MetroWest Engineering, Inc.

RE: Windsor Place, 24 School Street, Wayland MA

I have received your letter to Linda Hansen, Conservation Administrator and the Wayland Conservation Commission, dated June 6, 2018 containing review comments regarding the site plan set for proposed redevelopment of the property located at 24 School Street in Wayland. The Civil Drawings, Hydrologic Analysis and Stormwater Report have been revised to address the comments from your letter. The Site Plans, Sheets One through Five have been revised bearing a revision date of July 5, 2018. The Stormwater Report has been revised and bears a revision date of June, 2018. The Revised Stormwater Report includes; the Hydrologic Analysis, Operation and Maintenance Plan, and supporting calculations documenting compliance with the Mass DEP Stormwater Standards.

Comment Response to Nover-Armstrong Letter dated June 6, 2018
Windsor Place, 24 School Street, Wayland

SHEET 4 OF 5	DATE: SEPTEMBER 6, 2017
CALC'D BY: BTN	FIELD BK: 621
DRAFTER: BTN	PROJECT: WY_SCH
	CAD FILE: PROP_SITE_3_R10.dwg
	DWG FILE: SP090617_R2.dwg

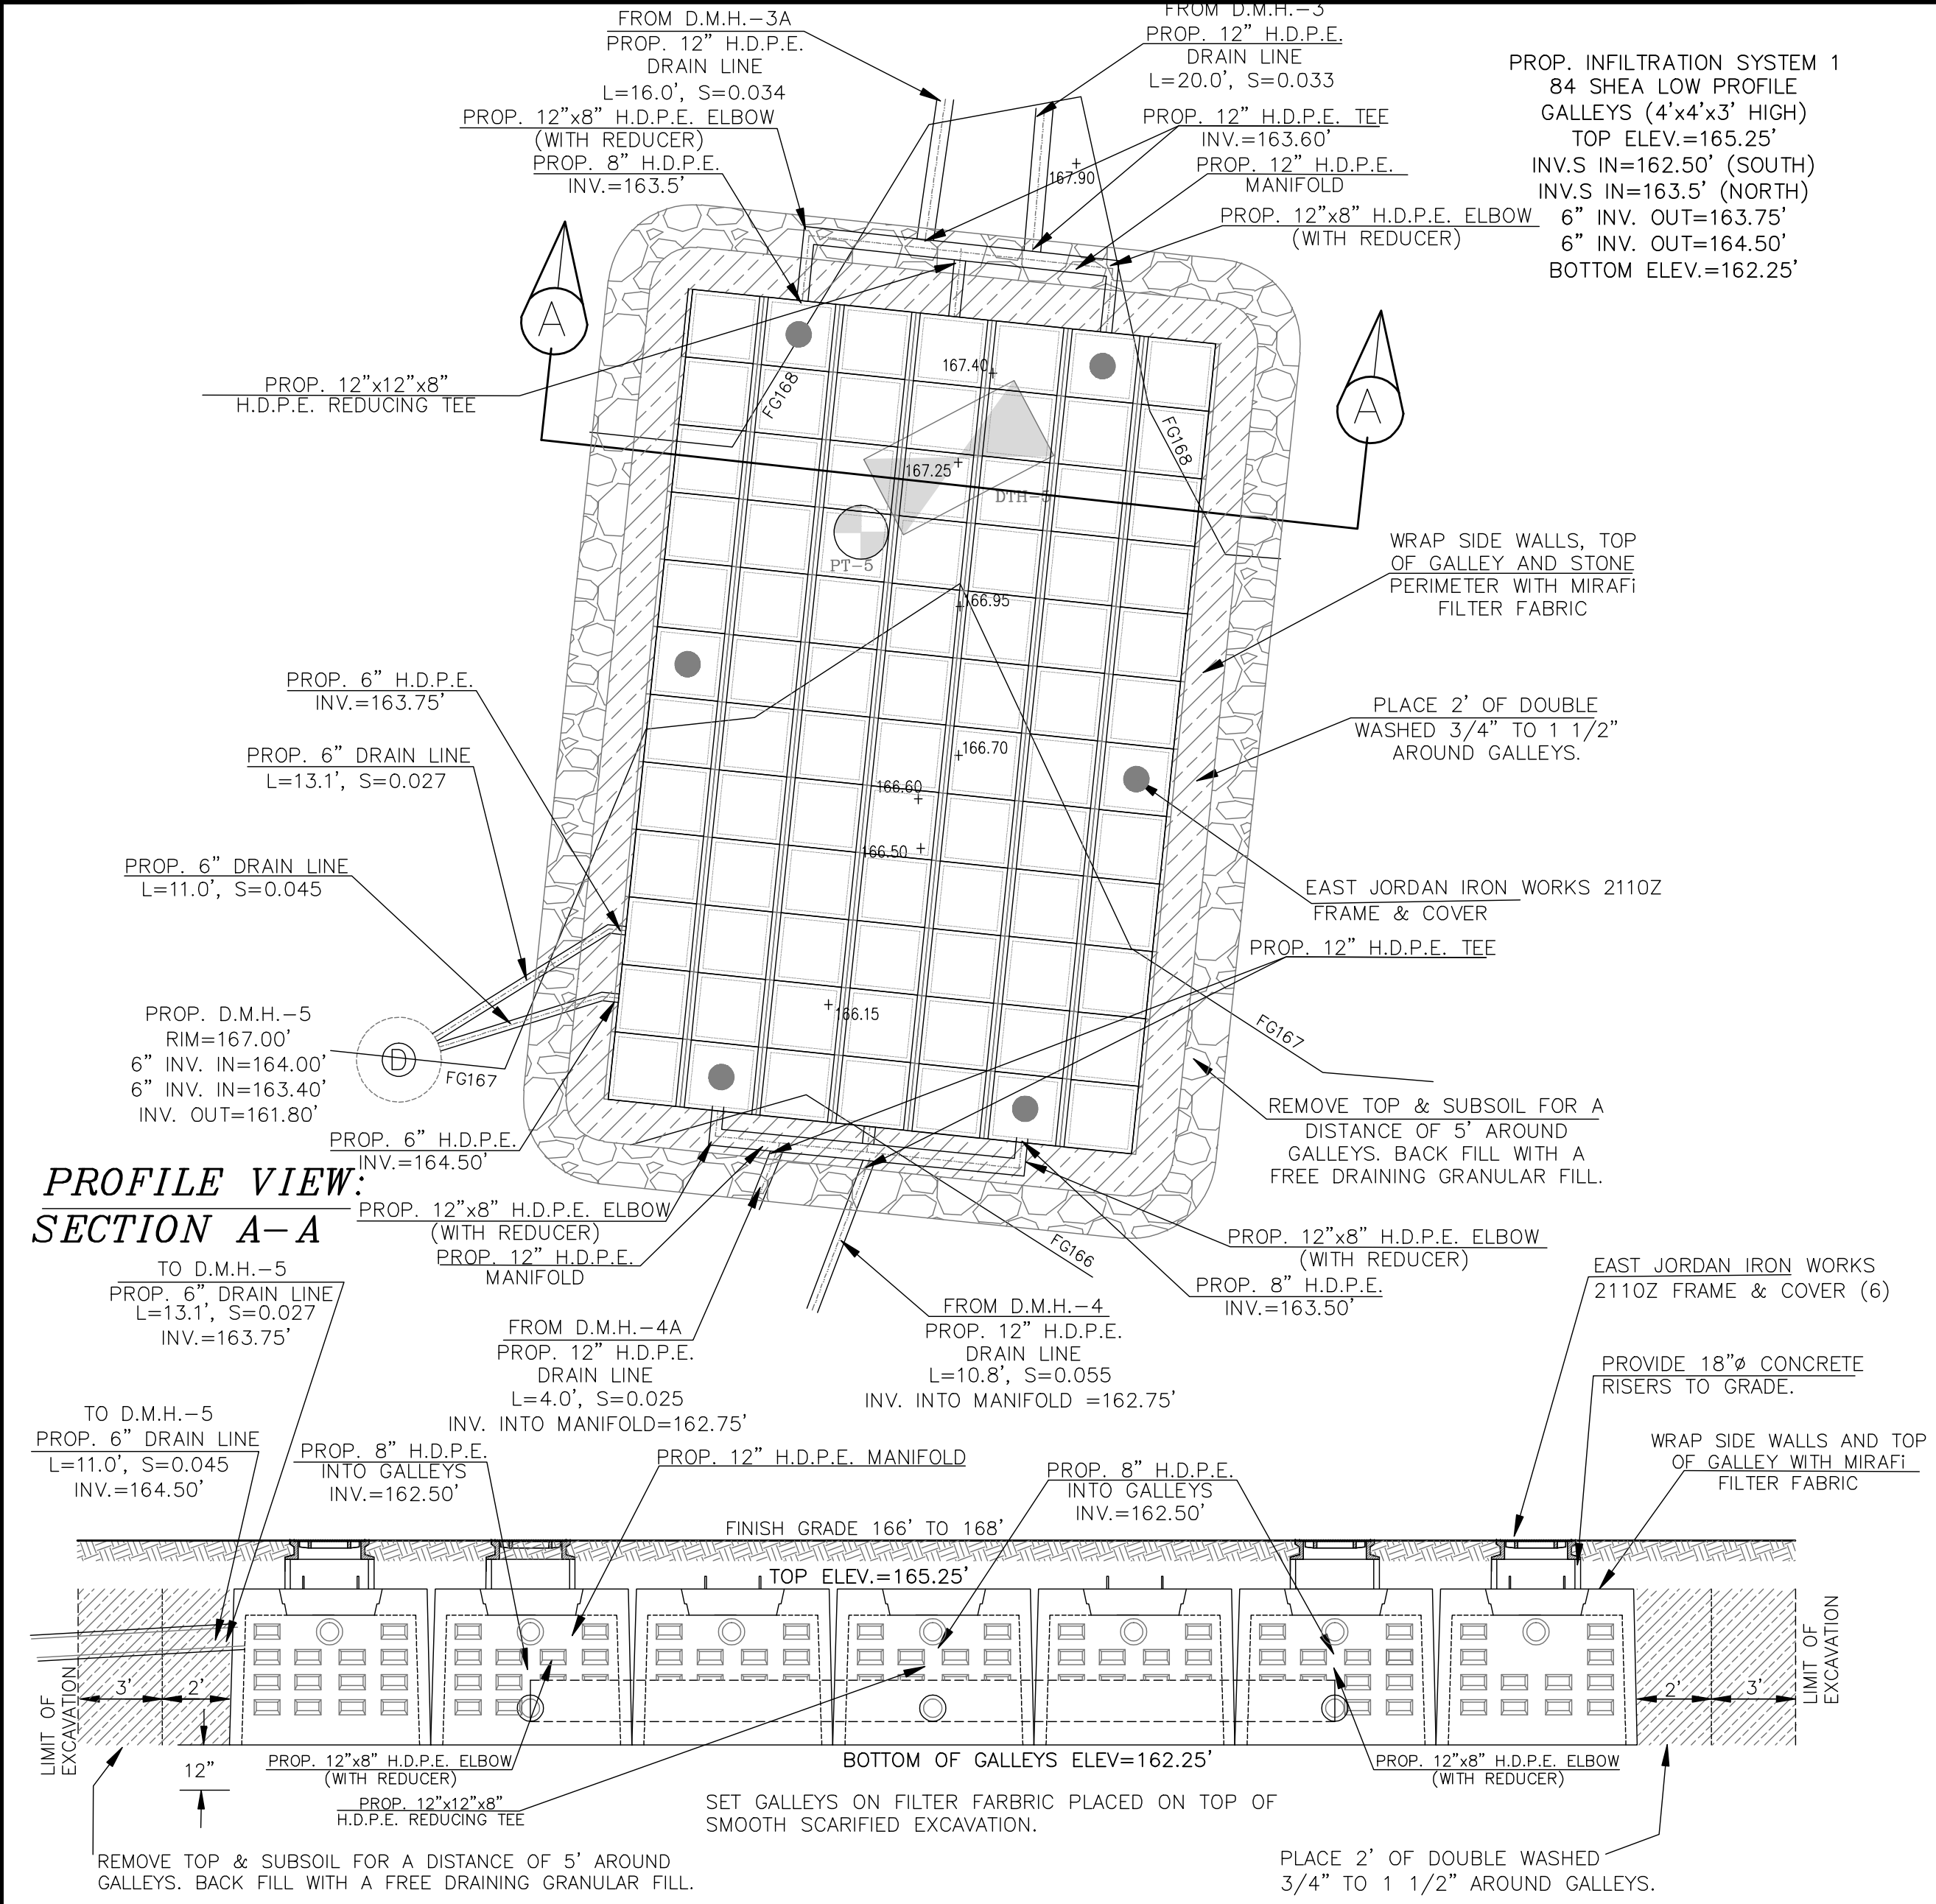
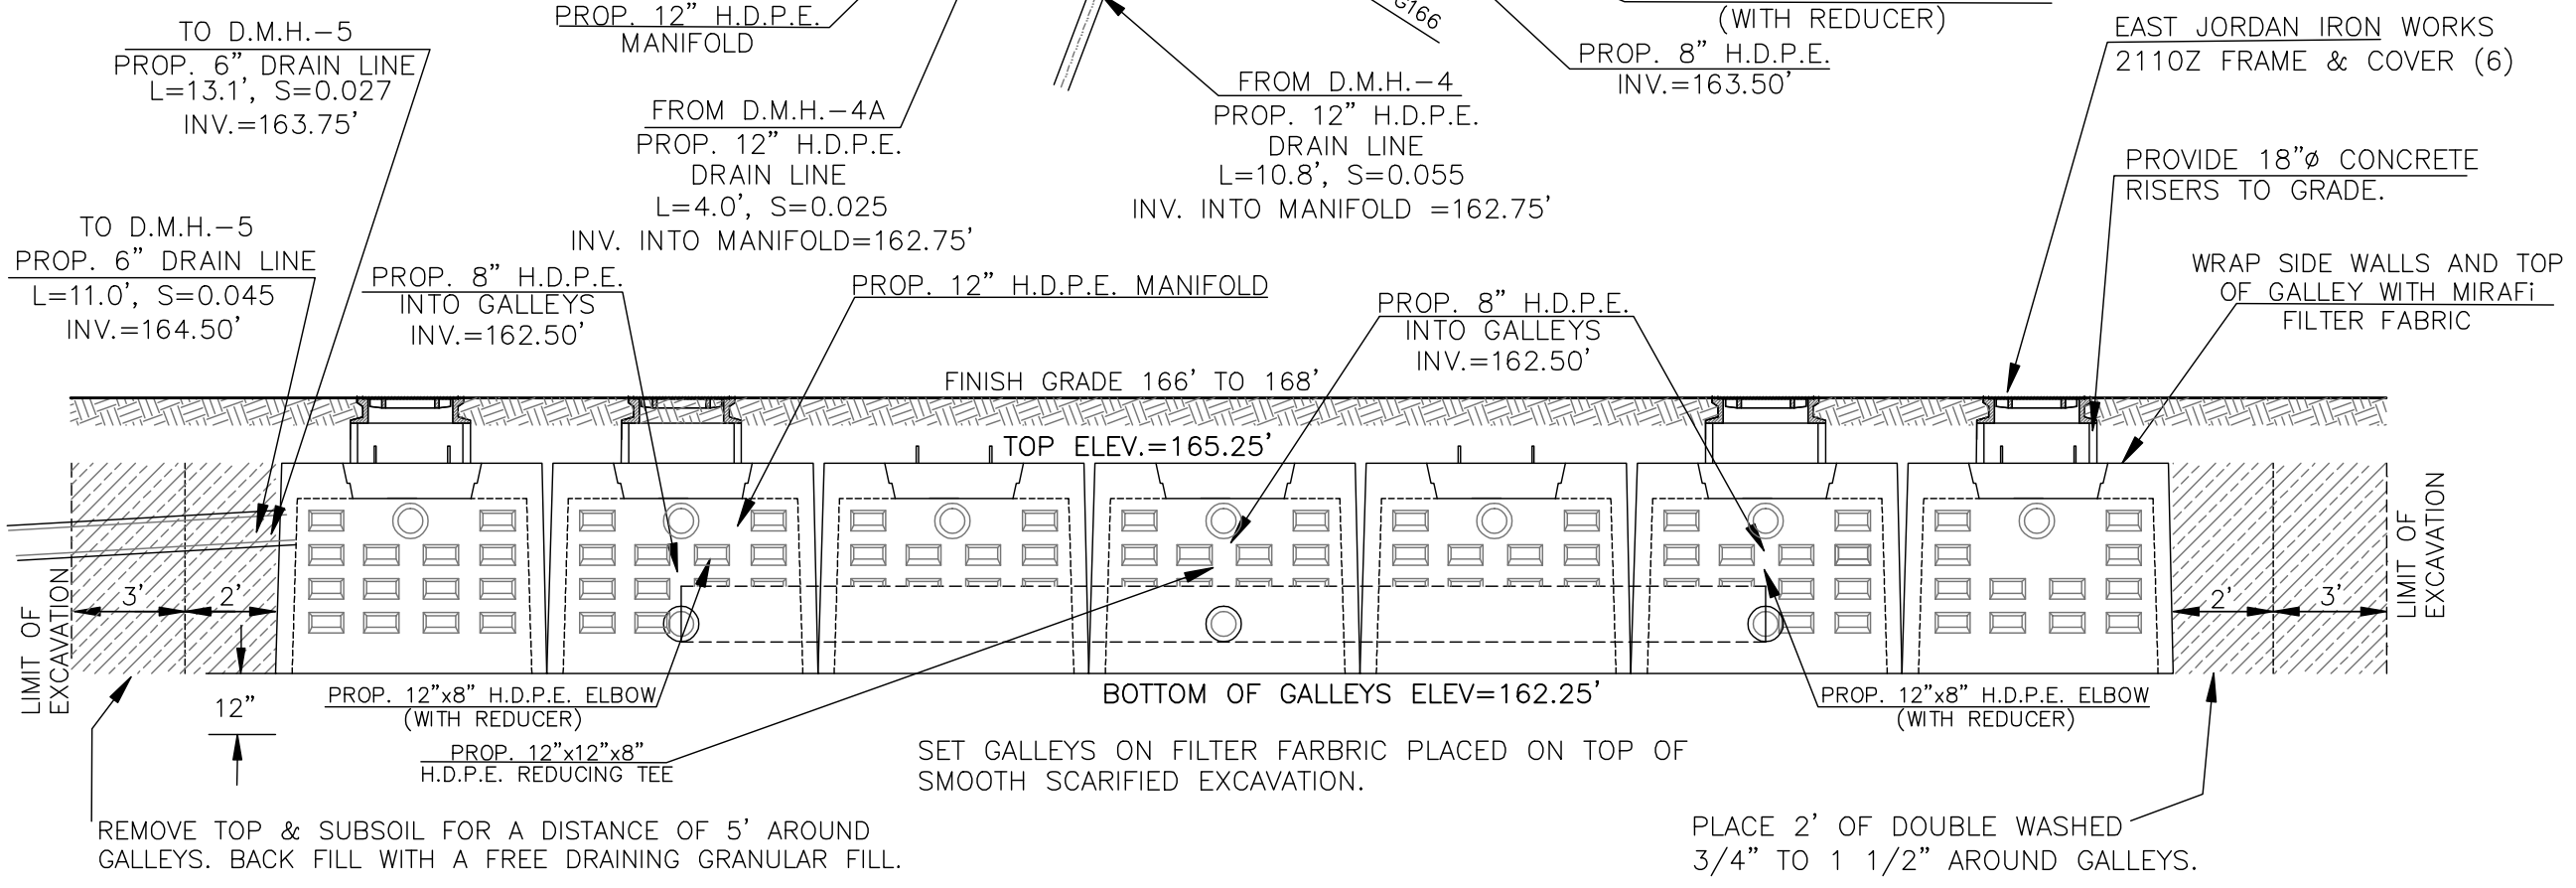
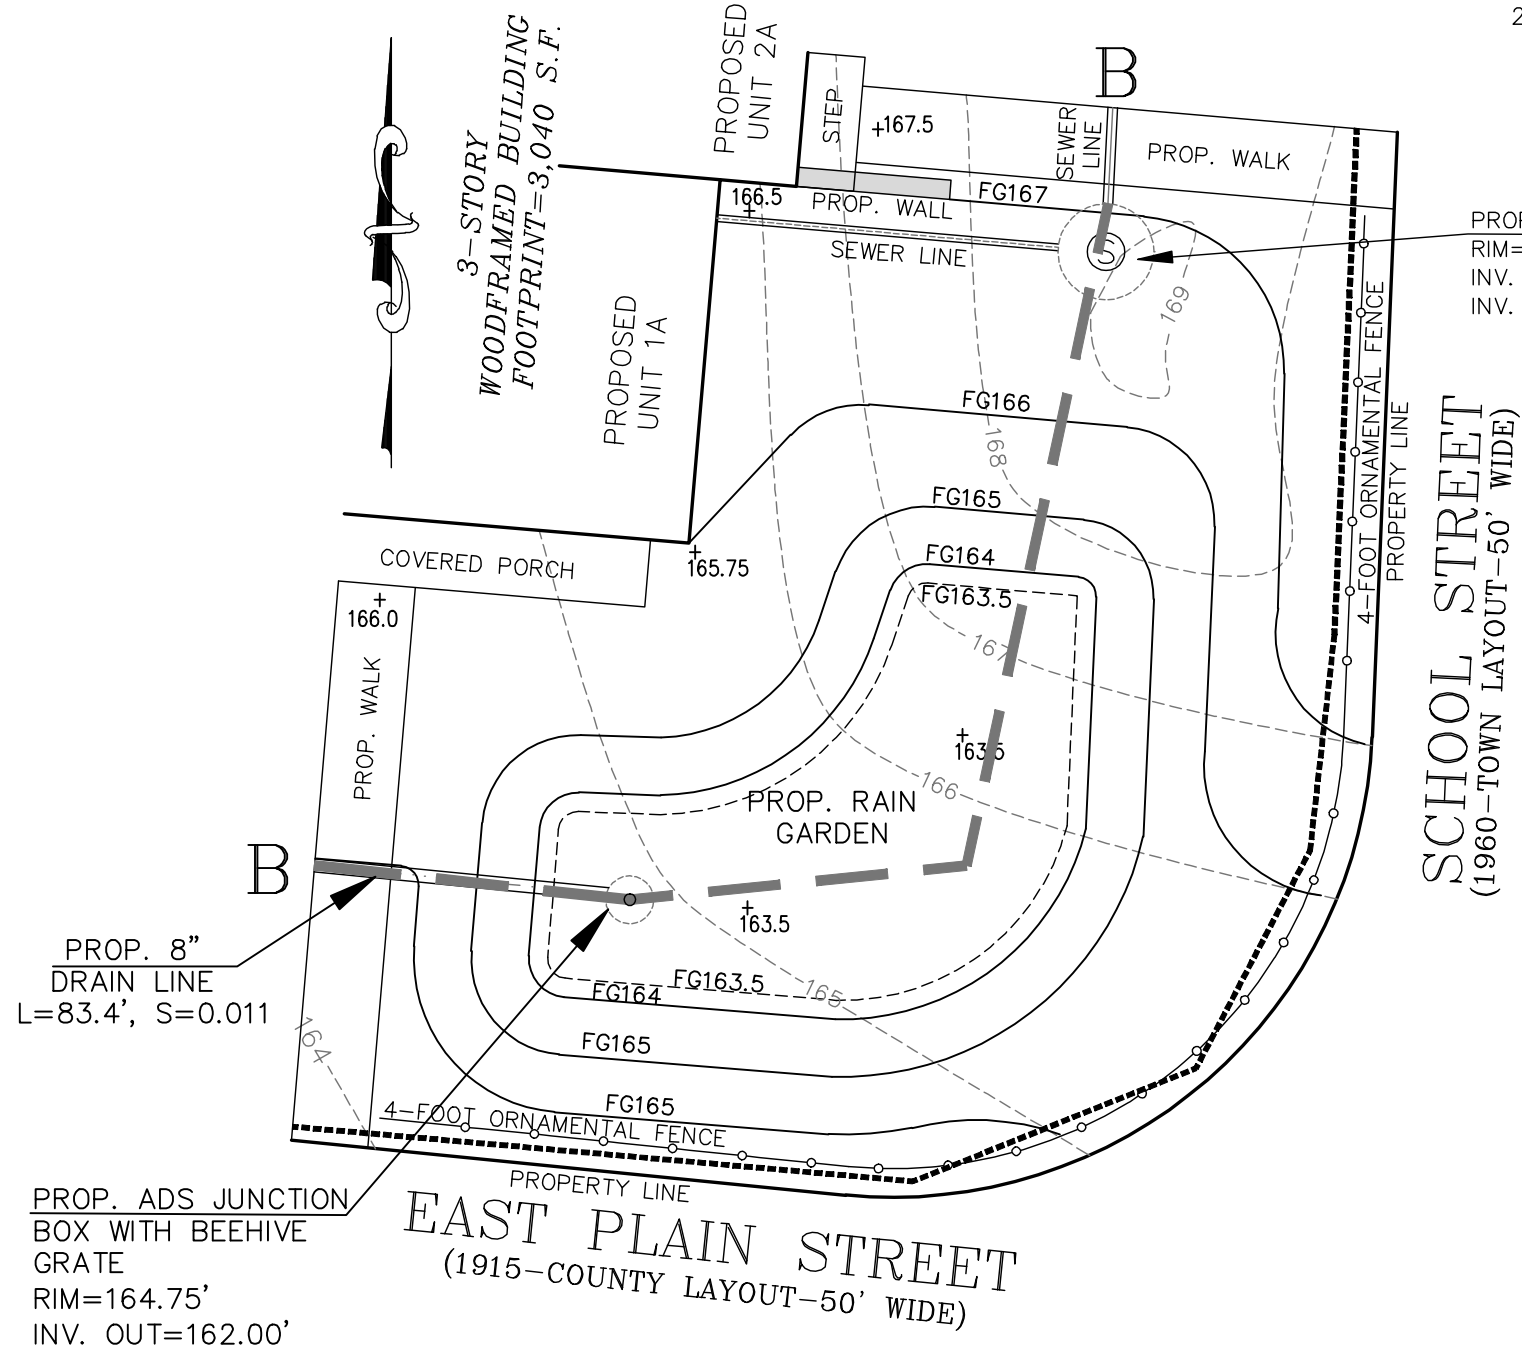
The subsurface infiltration BMP does not have the required 2 feet of separation from seasonal high groundwater. The March 12, 2018 groundwater level in MW 3 was 160.14 feet. On the plans and calculations by MWE, the bottom of the 3.0' high subsurface infiltration precast structure is 162.25 feet. The bottom of the crushed stone needs to be 2 feet above groundwater. The mounding calculations by CREATIVE used 162.25 as the bottom of the stone.

The two 6" diameter outlets from the infiltration BMP are labelled as 8" diameter on the plans and should be corrected.

The design of the Rain Garden BMP is not consistent with the Stormwater Handbook. The planting soil and stone specifications and thicknesses do not match the Handbook detail.

There are a lot of plants proposed for the Rain Garden. The planting schedule should be reviewed for spacing guidelines.

The 12-inch layer of stone has been replaced with a layer of filter fabric underneath the infiltration system and is shown on the *Proposed Details Plan*, Sheet 4 of 5.

The manifold materials are specified to be H.D.P.E. pipe for which elbows, reducers and tee fittings are readily available. The detail for the infiltration system and manifolds is shown on the *Proposed Details Plan*, Sheet 4 of 5. Connections into the galleys will be sealed with hydraulic cement.

The outlet pipes for the subsurface infiltration system have been labeled as 6-inch diameter on the *Proposed Site Plan* and *Proposed Details Plan*, Sheets 3 and 4 of 5.

The planting soil specification on the rain garden detail has been adjusted to be more consistent with the Stormwater Management Policy. The revised detail is shown on the Proposed Details Plan, Sheet 4 of 5. Additionally, the handbook provides guidance only and is not a design handbook.

The note specifying the use of "New England Wet Mix" seed blend has been removed from the Proposed Rain Garden Detail on the *Proposed Details Plan*, Sheet 4 of 5.

The planting schedule has been revised to reduce the quantity of plantings within the rain garden and is shown on the Proposed Rain Garden Detail on the *Proposed Detail Sheet*, Sheet 4 of 5.
